INDESIT company

Model type:
AVTL82EU

Commercial code:
F033195

n1040345: Replacement of drum lock button TL EVOII.

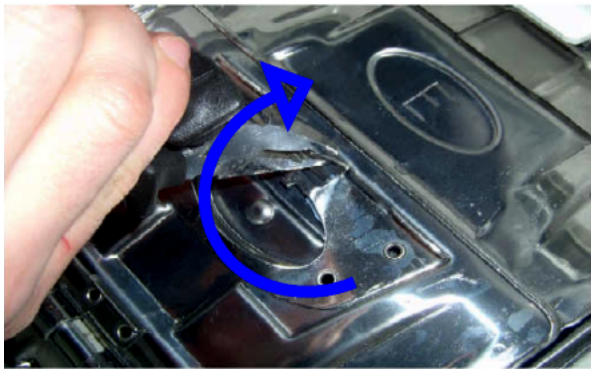
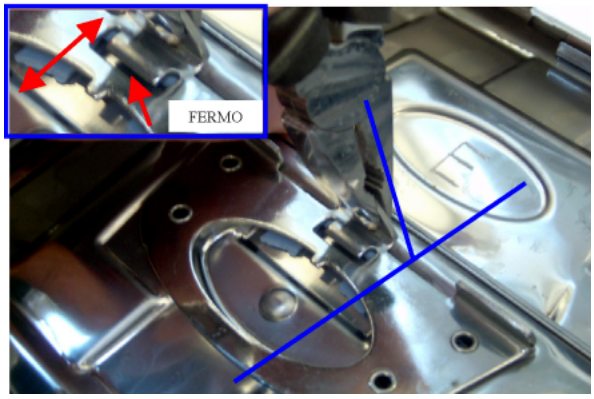
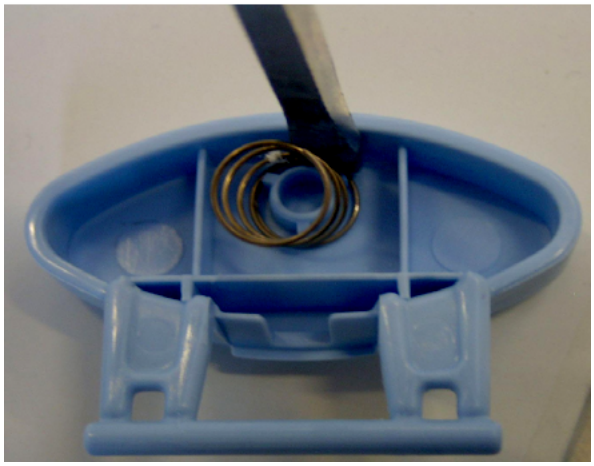
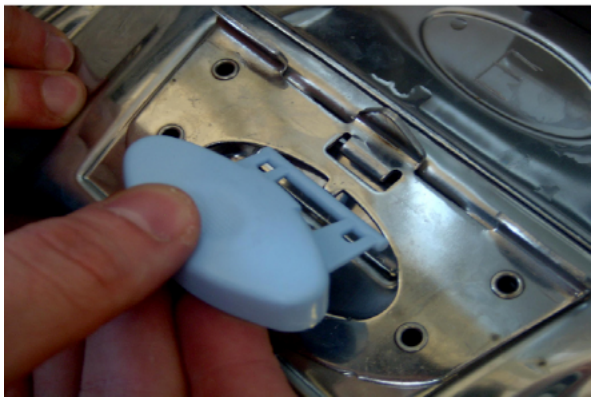
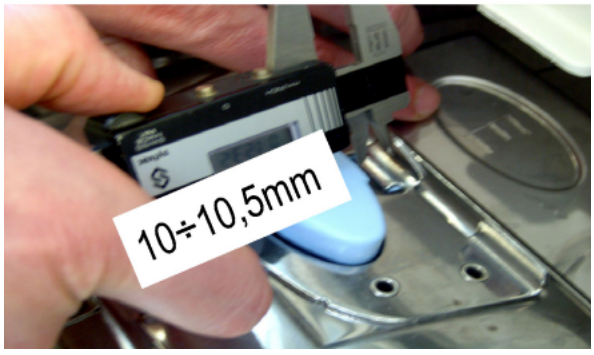
1) turn the central tip of the catch in the direction shown (FIG.1);

2) bring the tip to a vertical position and ensure that the broken button is disengaged from the catch restraint and can be removed (FIG.2);

3) remove the remaining part of the button with the aid of a screwdriver, taking care not to scratch the doors (FIG.3);

4) pre-assemble spring to button (FIG.4);

5) insert button between catch and door (FIG.5);

6) bring the button into position and arrange the spring in its location in the door (FIG.6);

7) turn the central tip of the catch in the direction shown to return it to its starting position (FIG.7);

8) check the distance between button and catch (FIG.8);

9) check correct operation of the button when opening and closing the doors (slight inclination errors of the catch can result in faulty closing of the doors) (FIG.9).

n1040382: Drain pump with bayonet-style filter - top Loading Brembate

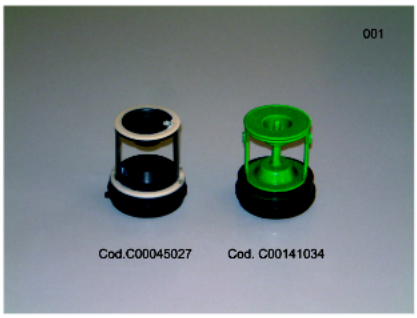
From serial no. 51021.0001 a new drain pump with bayonet-style filter has been installed on all top loading washing machines manufactured in Brembate.

New parts:
C00141862 - Drain pump
C00141034 - Pump filter kit

Premodification parts:
C00111409 - Drain pump
C00045027 - Pump filter kit

The new parts can be used instead of premodification ones.

N1040404FIG1

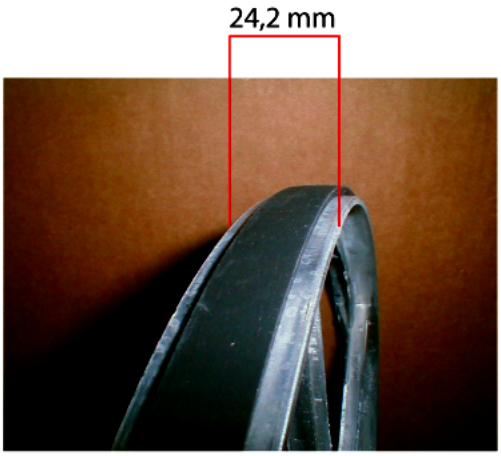
From serial no. 51202.0001 the pulley track has been widened from 21.2mm to 24.2mm (see picture N1040404FIG1).

new pulley
C00142832 - D280 24.2 mm track

Premodification pulley
C00083912 - D280 21.2 mm track

The new pulley can also be used on premodification versions of the models referred to in this release.
